Memorandum

Subject: Review of Thomas Turf Grass Permit Application Packet

DBS&A has reviewed the operating permit application packet submitted by Thomas Turf Grass for a well located in Bastrop County. The well is located near the town of Paige, west the intersection of Highway 290 and Highway 21, as shown in Figure 1 below.

Figure 1. Location of proposed Thomas Turf Grass well.

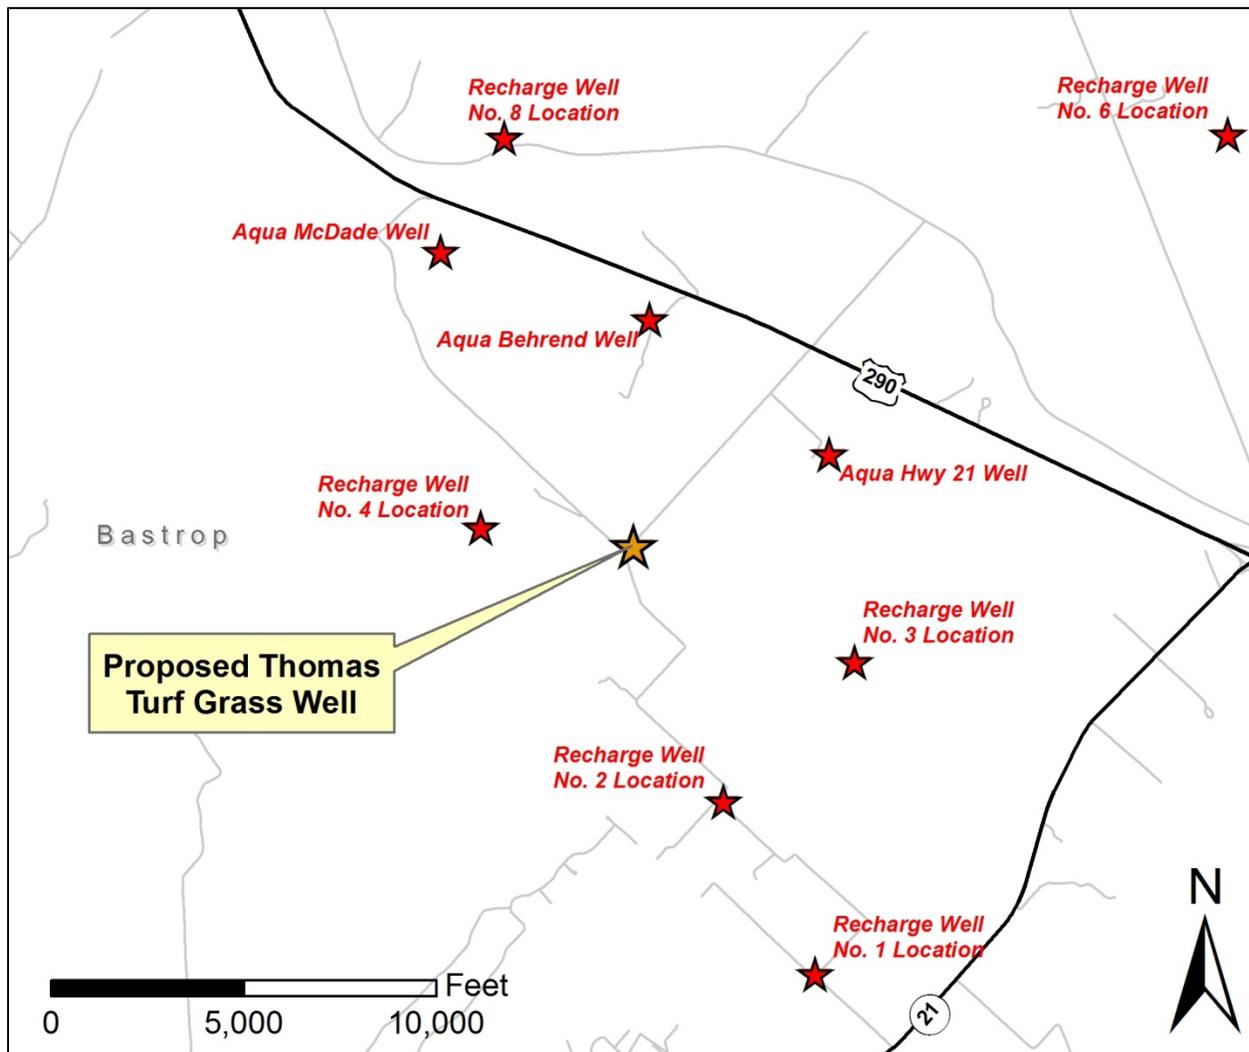
The proposed well will produce from the Simsboro Aquifer. As shown in Figure 1, this well is located near several existing Simsboro Aquifer wells and near several proposed Simsboro Aquifer well locations in the pending Recharge (formerly End Op) permit application. The Thomas Turf Grass well is approximately 4,000 feet east of the Recharge Well No. 4 location, which is less than the spacing requirement for a well of this size. However, a spacing variance request addressing this issue has been received by the District and is under consideration. The proposed well is also within 10,000 feet of several Aqua wells and other proposed Recharge well locations, all of which also produce or will produce from the Simsboro Aquifer. However, there is no violation of spacing requirements related to these other wells.

Figure 2. Project-specific 50-year drawdown (in feet) in the Simsboro Aquifer attributable to the proposed Thomas Turf Grass pumpage estimated by the GAM

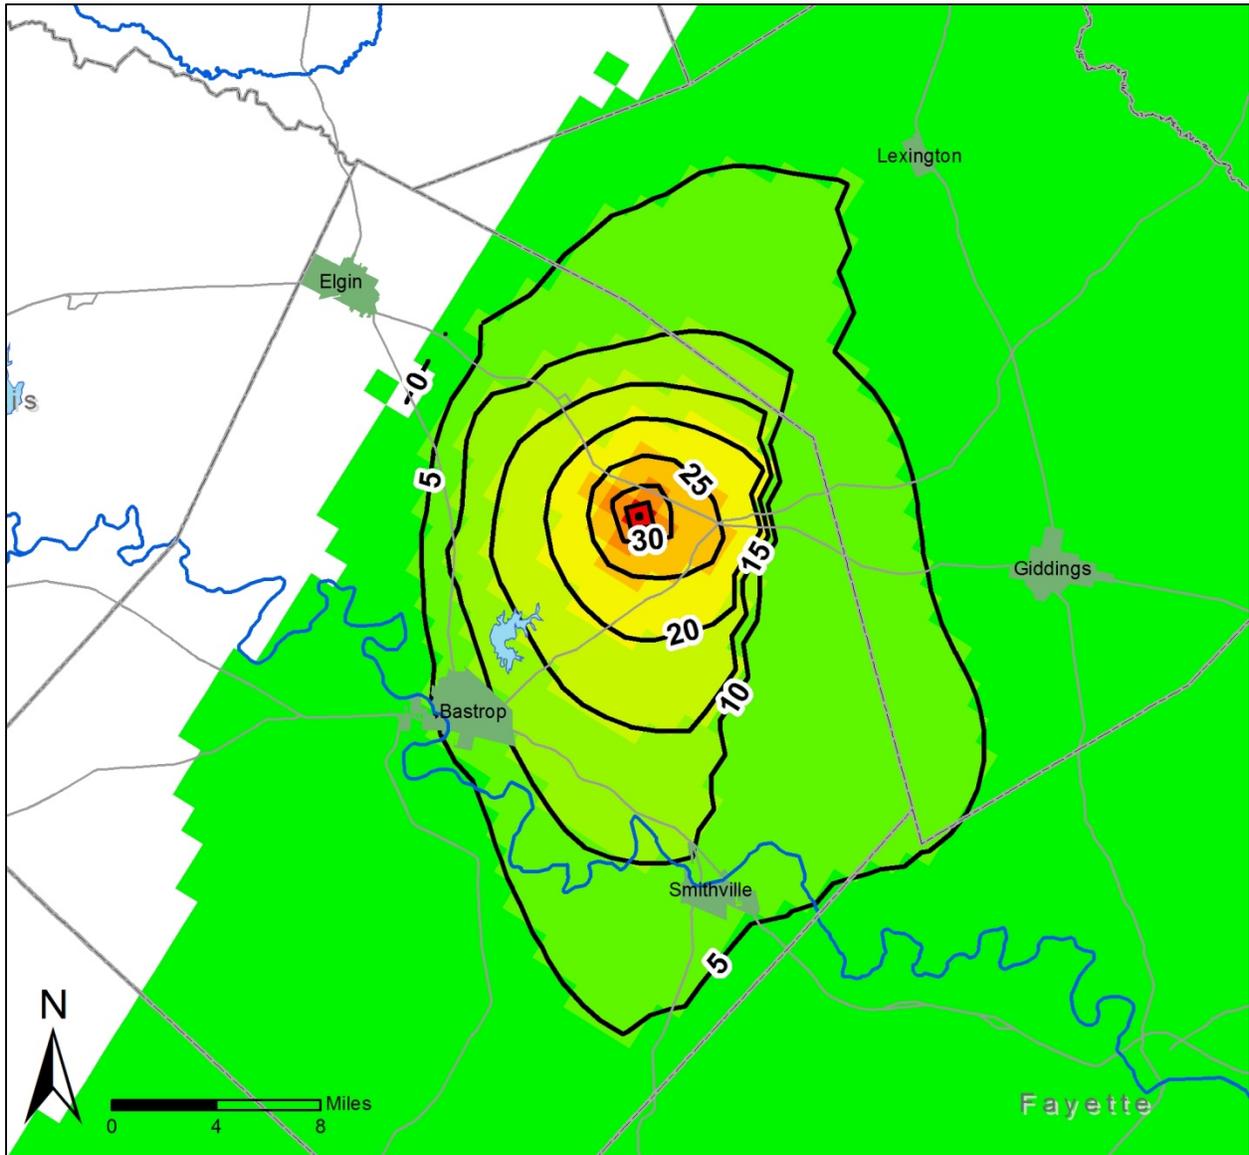
The Central Queen City-Sparta Groundwater Availability Model (GAM) was run with the proposed pumpage of 2,200 acre-feet per year (ac-ft/yr) added in the model cell in which the proposed well is located. The results of this model run are shown in Figure 2, which illustrates that at the end of 50 years of continuous pumping, the project-specific drawdown due to the proposed Thomas Turf Grass well (i.e., drawdown caused by the pumpage from the well only) is approximately 40 feet at the well location. The model run indicates that the nearby Aqua wells may experience more than 30 feet of drawdown due to pumping from the proposed Thomas Turf Grass well, and many of the proposed Recharge well locations may experience a similar drawdown amount. These drawdown estimates are obtained using the GAM, which was developed to assess groundwater impacts on a regional basis. However, it is reasonable to conclude that the pumpage from the proposed Thomas Turf Grass well may result in tens of feet of drawdown in the nearby permitted wells and proposed permitted well locations.

The proposed production of 2,200 ac-ft/yr by Thomas Turf Grass from a well in Bastrop County will impact water levels in the Simsboro Aquifer in the District. Drawdowns estimated using the GAM are summarized in Table 1. As indicated in the table, the drawdown estimated to occur due to the proposed well is approximately six feet when averaged across the entire District. A map of well-specific drawdowns estimated using the GAM is shown in Figure 2. The proposed
